# Access Compliance Report

## Public Rights-of-Way

### (Curb Ramps)

Intersection ID: 28929	Main Street: WADE_ARDREY_RD	Cross Street: CAMPBELL_HALL_CT	Location: NE
ADA ID: 957076C5D209	Ramp Type: Perp	Initial Pass/Fail: Fail	Overall Compliance: No
Severity Score: 18.75			
Codes/Mitigation Info/Possible Solution		Field Measurements/Component Compliance

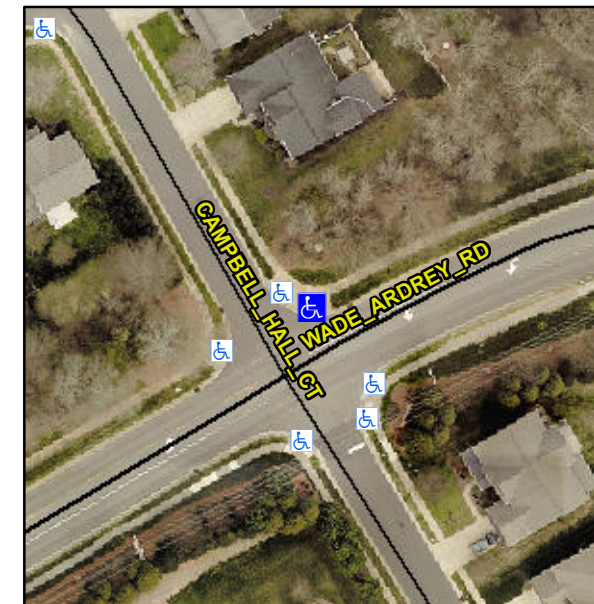
**Not Found, R304.5.1**

Compliance	Description	Data	Compliance	Description	Data
N/A	Ramp Length (in)	93.0	Yes	Ramp Slope (%)	5.8
No	Ramp Width (in)	34.0	Yes	Ramp XSlope (%)	5.0
N/A	Flare Type LT	N/A	N/A	Flare Type RT	N/A
N/A	Flare Slope LT (%)	N/A	N/A	Flare Slope RT (%)	N/A
N/A	Flare Traversable LT?	N/A	N/A	Flare Traversable RT?	N/A
N/A	Landing Length (in)	N/A	N/A	DWS Provided?	N/A
N/A	Landing Width (in)	N/A	N/A	DWS Contrast?	N/A
N/A	Landing Slope (%)	N/A	N/A	DWS Length (in)	N/A
N/A	Landing X Slope (%)	N/A	N/A	DWS Full Width?	N/A
N/A	Landing Curb? (Y/N)	N/A	N/A	DWS Offset (in)	N/A
N/A	Shared Landing?	N/A			
N/A	Gutter Ponding?	N/A	N/A	Gutter Slope (%)	N/A
N/A	Gutter Lip Ht (in)	N/A	N/A	Gutter X Slope (%)	N/A
N/A	Painted X Walk1?	No	N/A	Painted X Walk2?	N/A
	X Walk 1 Direction	To SE		X Walk 2 Direction	N/A
N/A	X Walk 1 Width (in)	N/A	N/A	X Walk 2 Width (in)	N/A
	X Walk 1 Slope (%)	1.8		X Walk 2 Slope (%)	N/A
	X Walk 1 X Slope (%)	5.4		X Walk 2 X Slope (%)	N/A

**Remove & Replace Entire Ramp.**
